Arlington High School Building Committee
Finance Subcommittee Meeting
Thursday, July 18, 2024
Conducted by Remote Participation
4:00 PM – 4:30 PM
Agenda

7/18/24 AHSBC Finance Subcommittee Meeting Meeting Materials

1. Motion to approve Consigli's Change Order #42 for \$77,519.91
2. Motion to approve Consigli AHS Requisition #51 for \$2,334,539.70
3. Motion to approve HMFH Amendment #9 for \$36,135.00
4. Motion to approve Budget Revision Request #7

1 LIGHTING STADIUM TOILET BUILDING PLAN
1/4" = 1'-0"

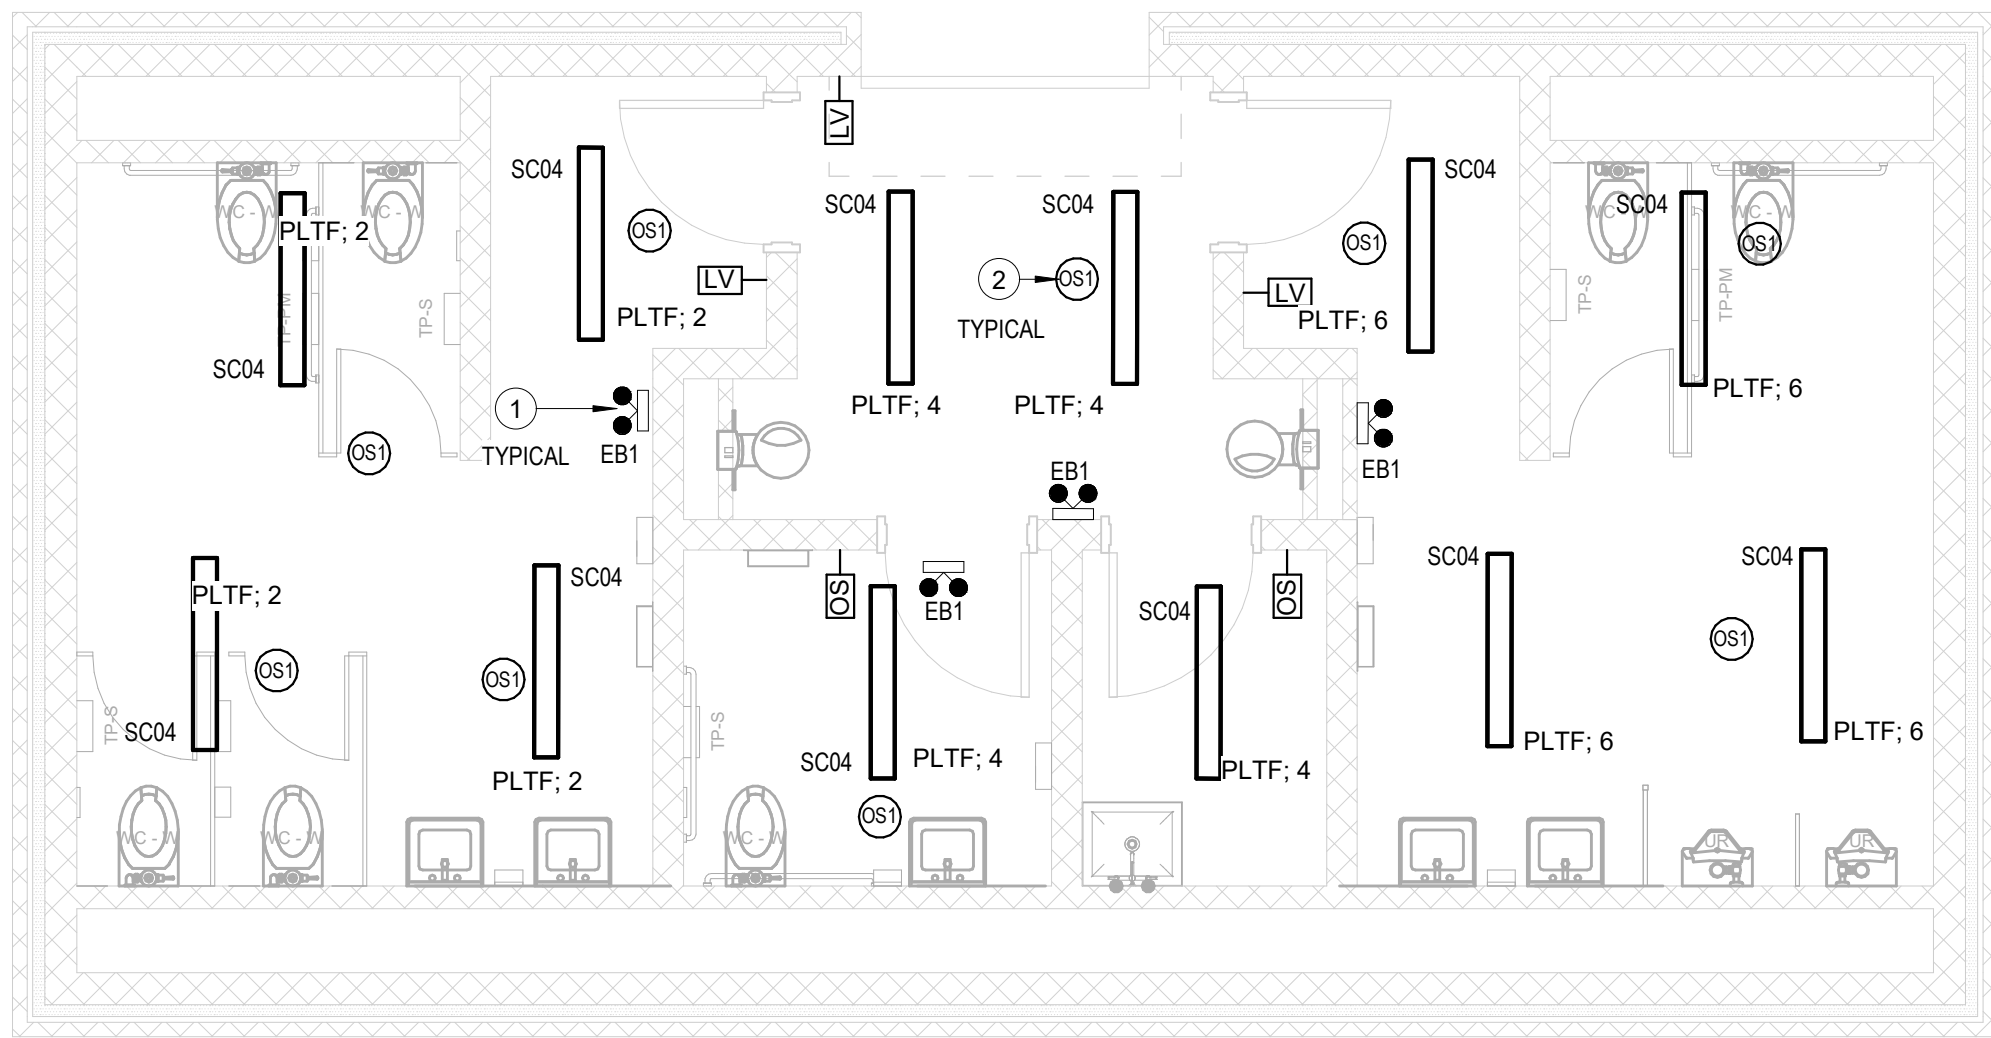
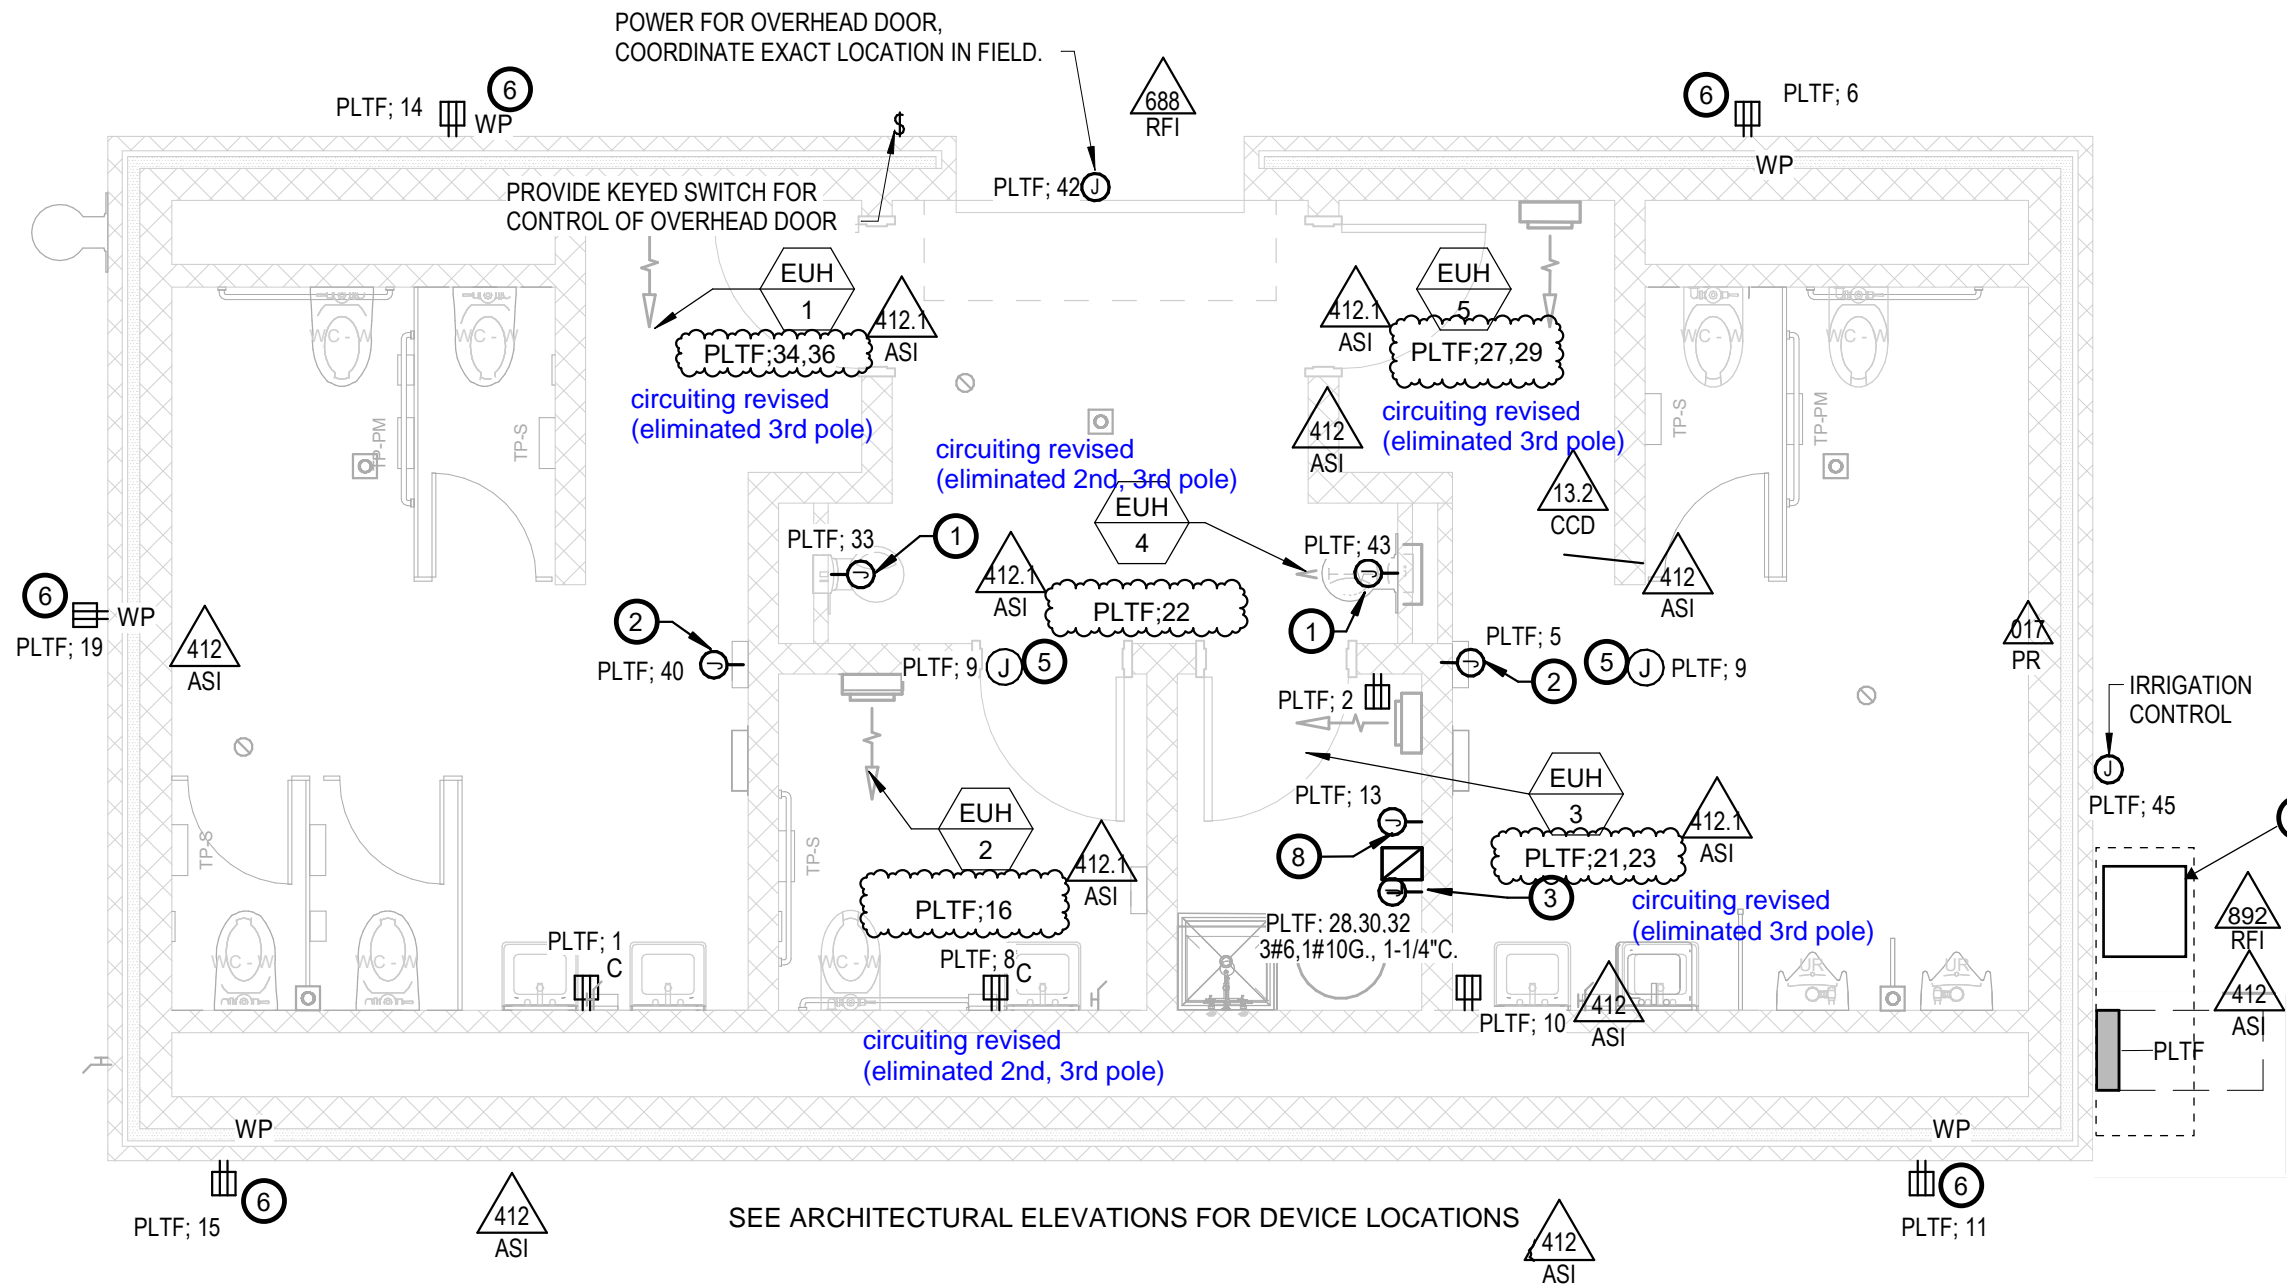
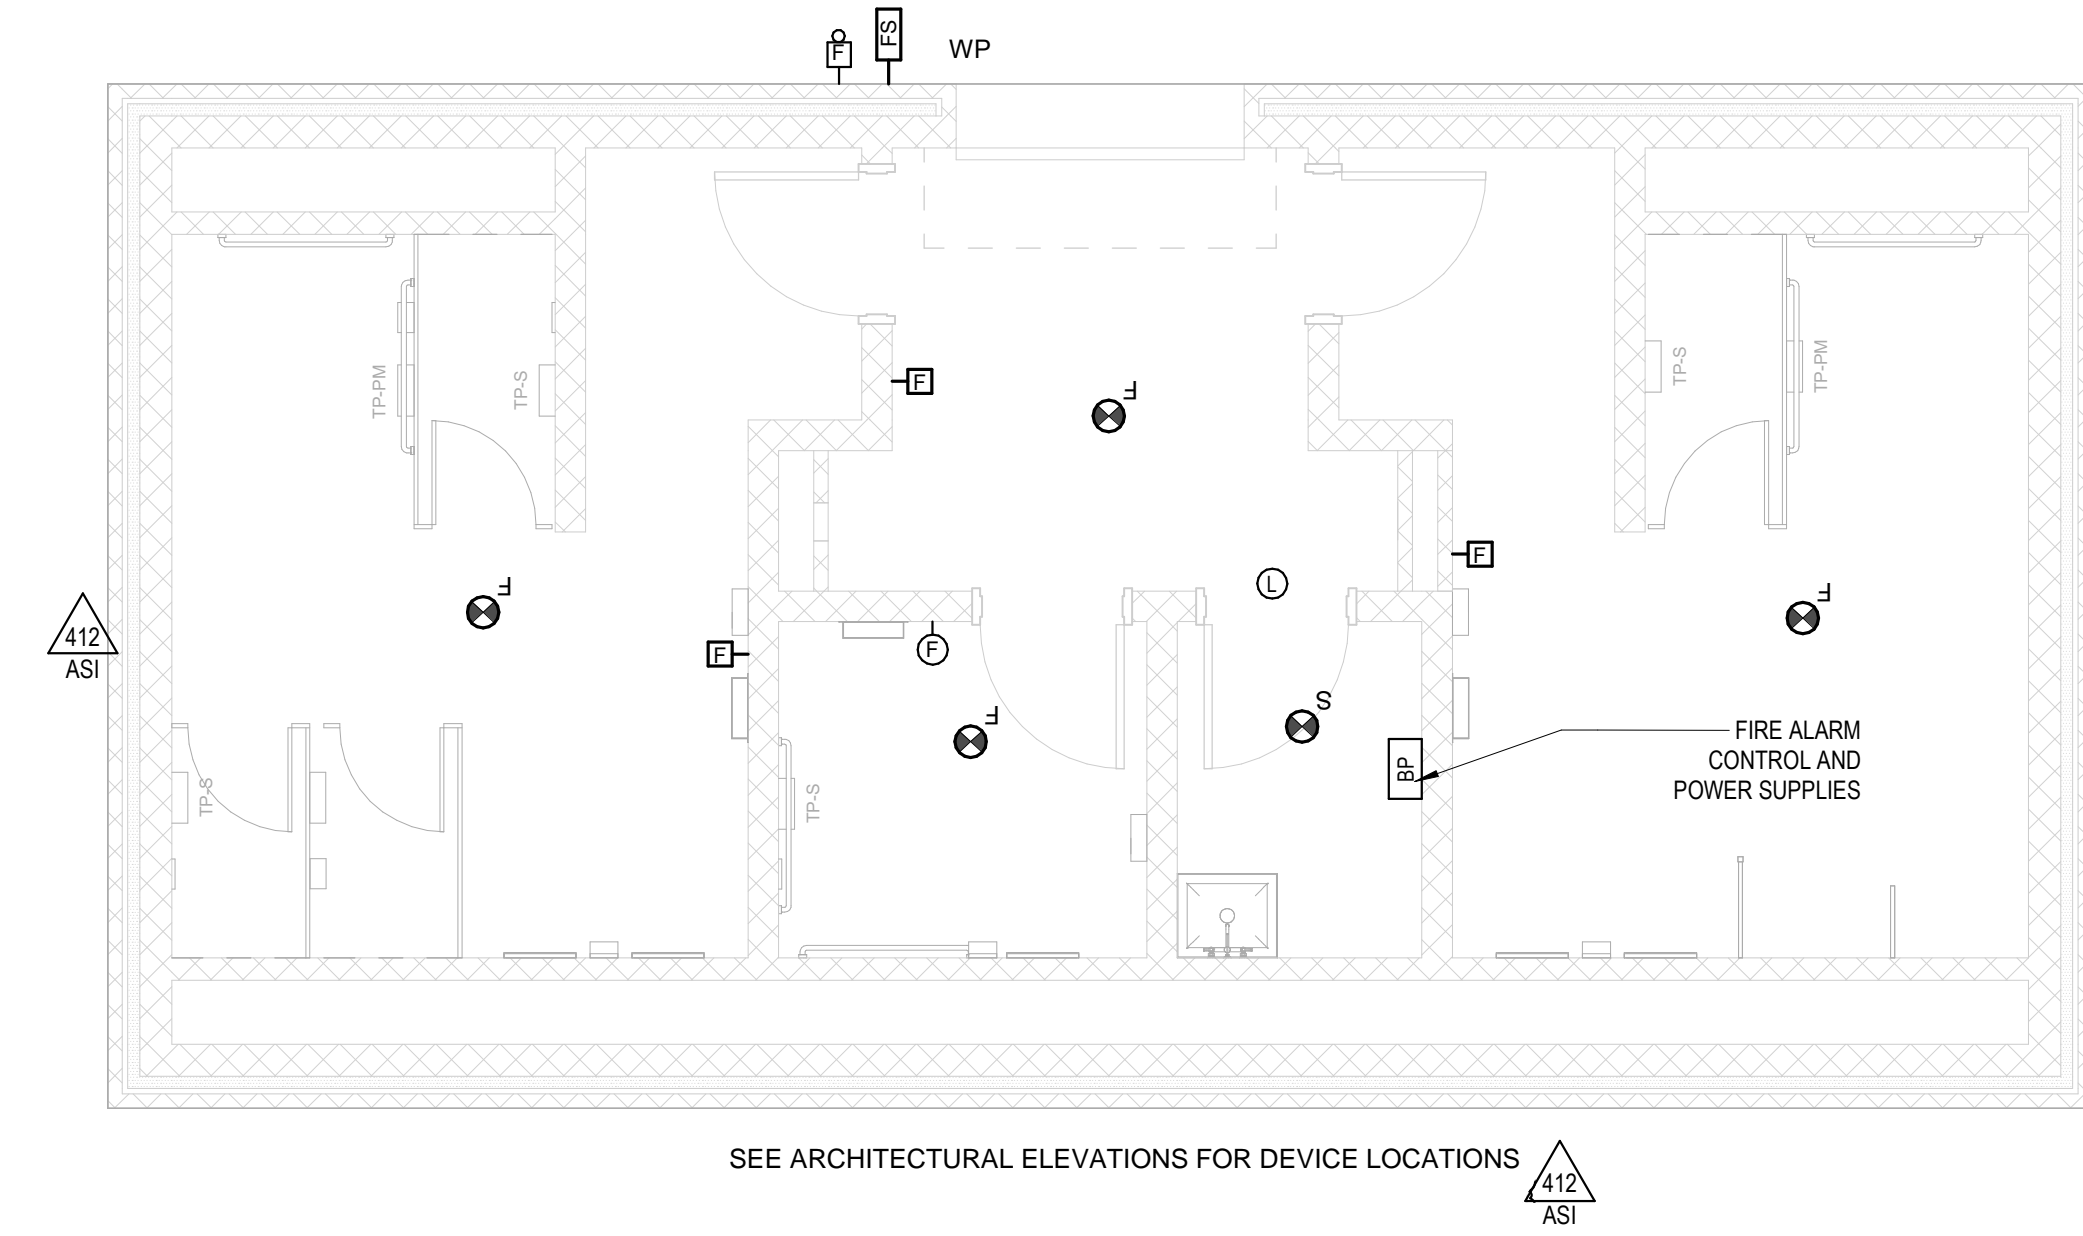
Electrical: Various revisions: Deleted FA Pull station, revised location of electrical outlets, incorporation of RFI-892 Response. **See Reissued sheet E9.0.**

Revision to breakers.
3-pole changed to
2-pole and Amp
revised.
Added spare

Revision to breakers.
3-pole changed to
1-pole, added spares

Revision to breakers.
3-pole changed to
2-pole and Amp
revised.
Added spare

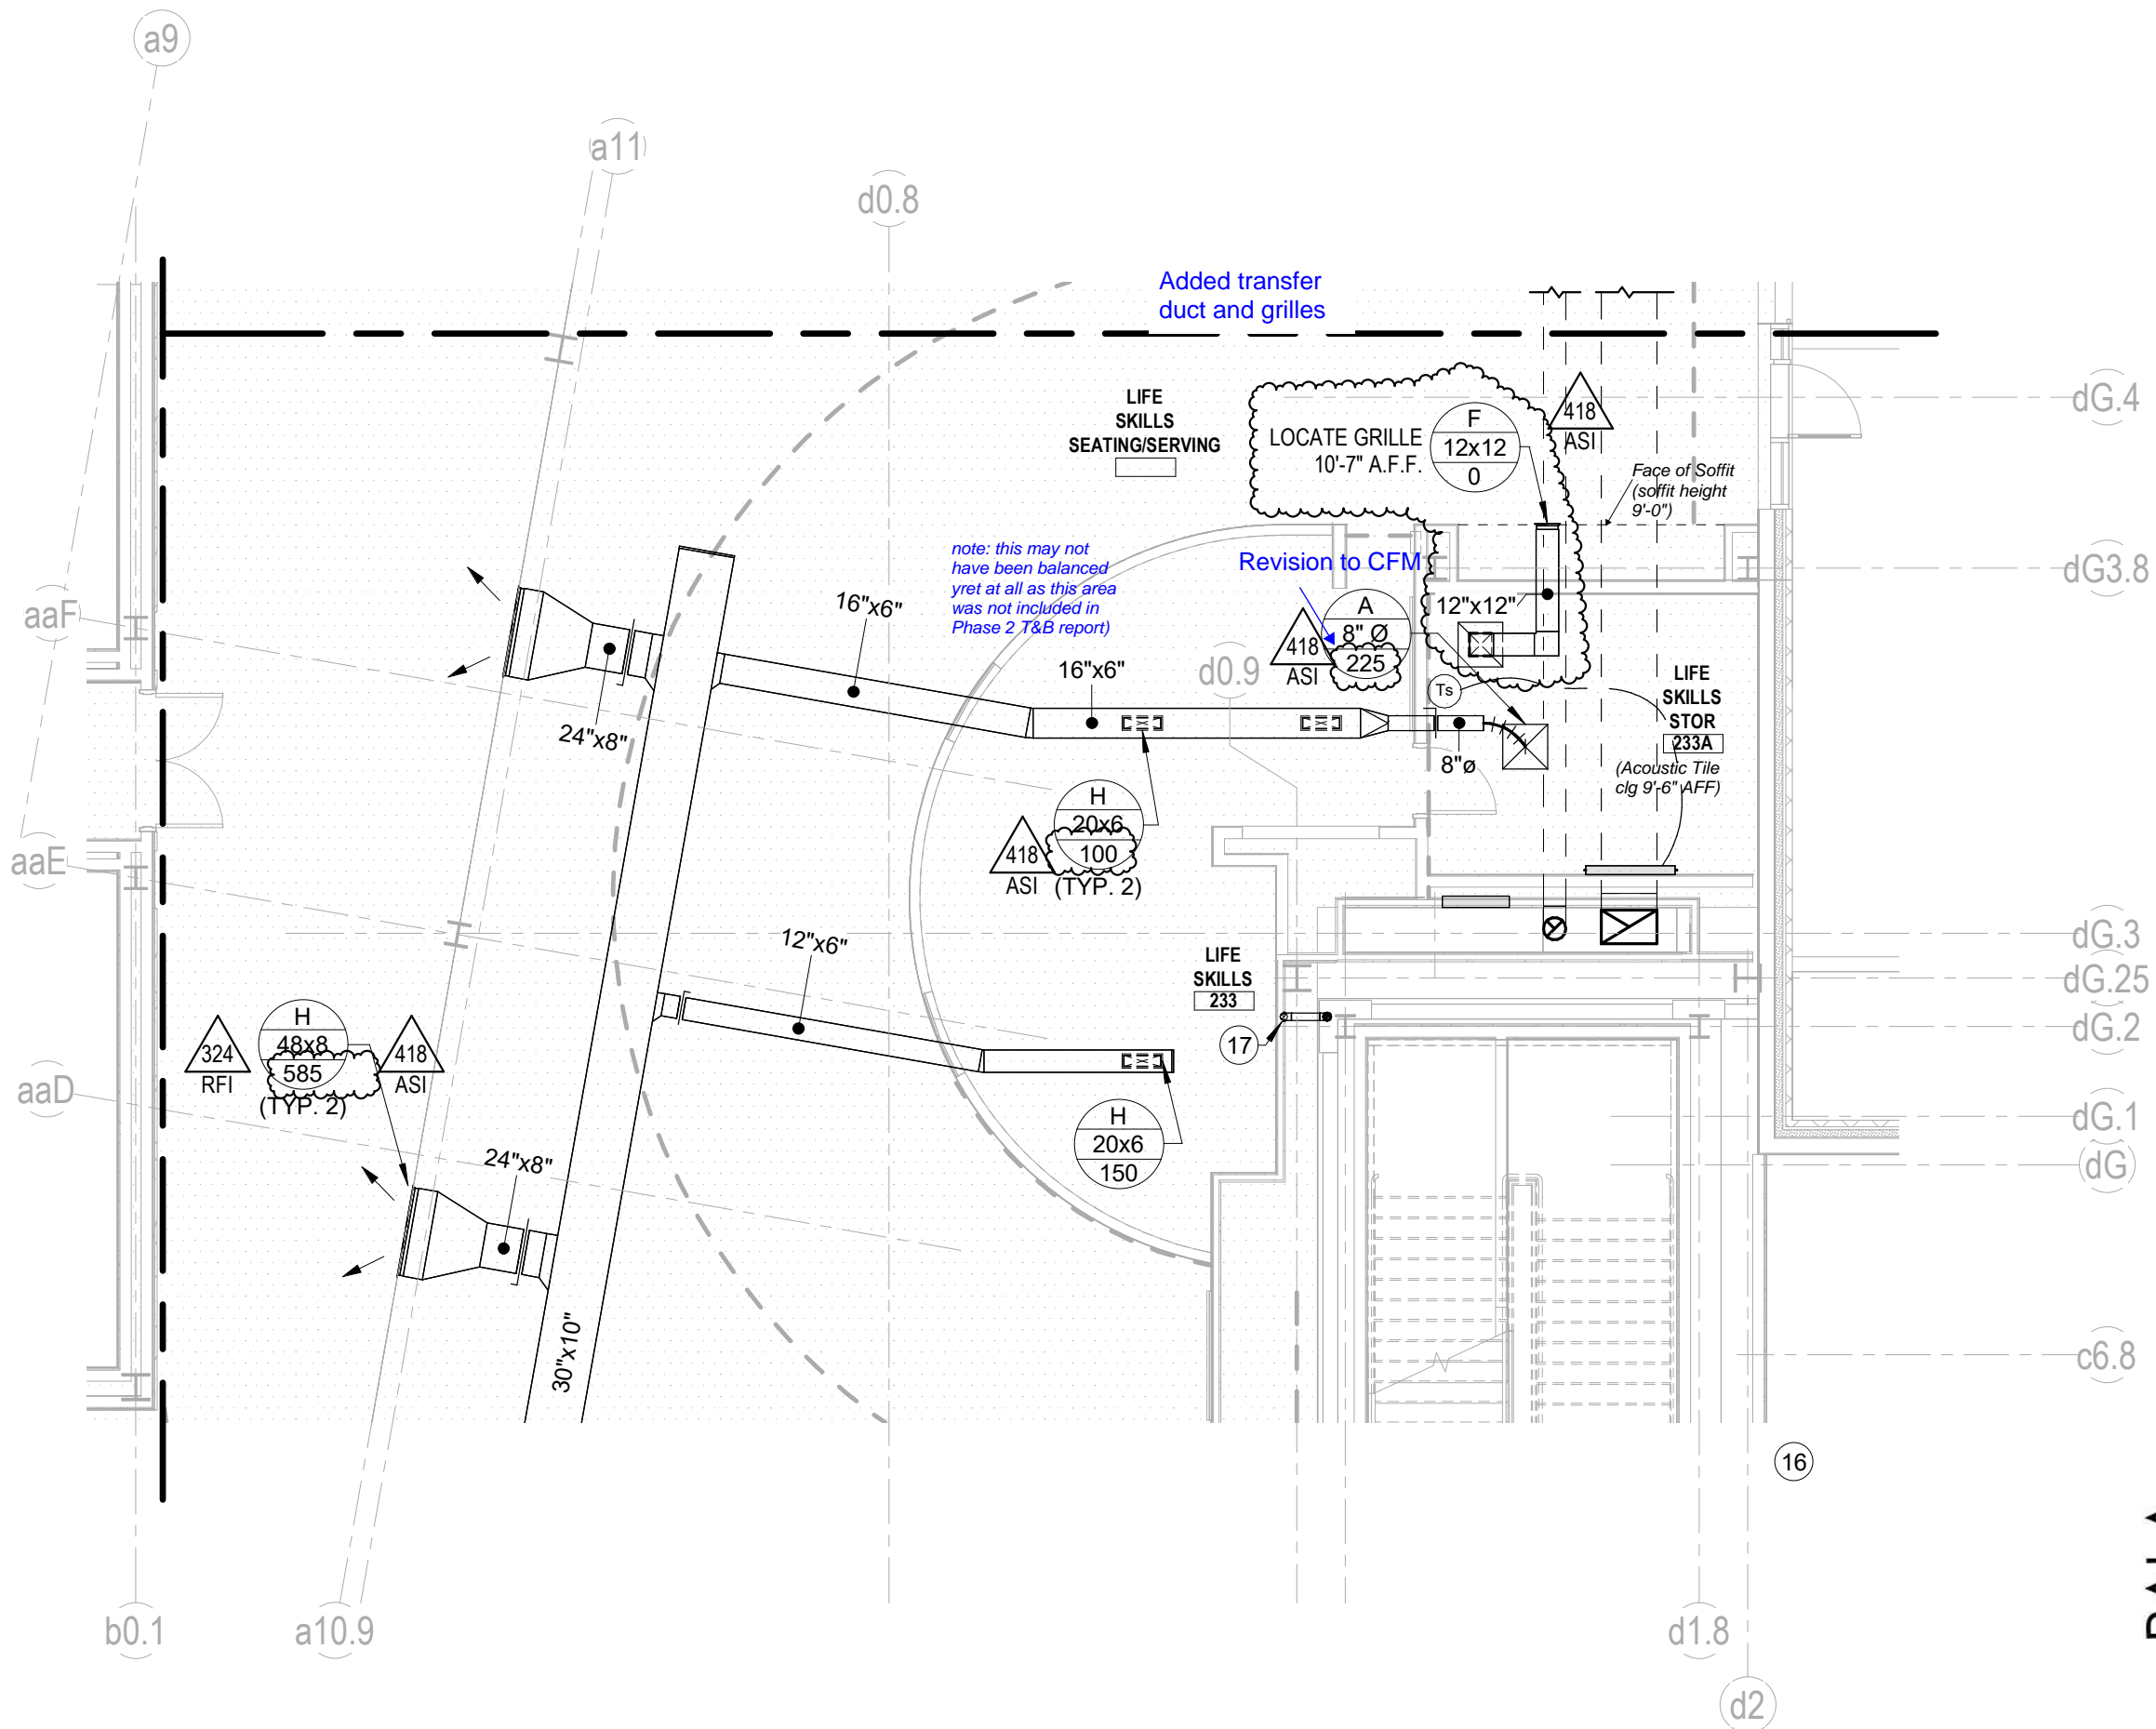
Part a 1st floor: Added Transfer Duct at Ice/Laundry Room 124. Revised CFM for associated room unit VAVs 23-A-1. **See reissued sheet M2.0a.**

Note: this had been annotated on Duct Coordination Drawing.

Part a 1st floor: Revised locations of Tstats within LABBB CR's 132 and 134. **See reissued sheet M2.0a**
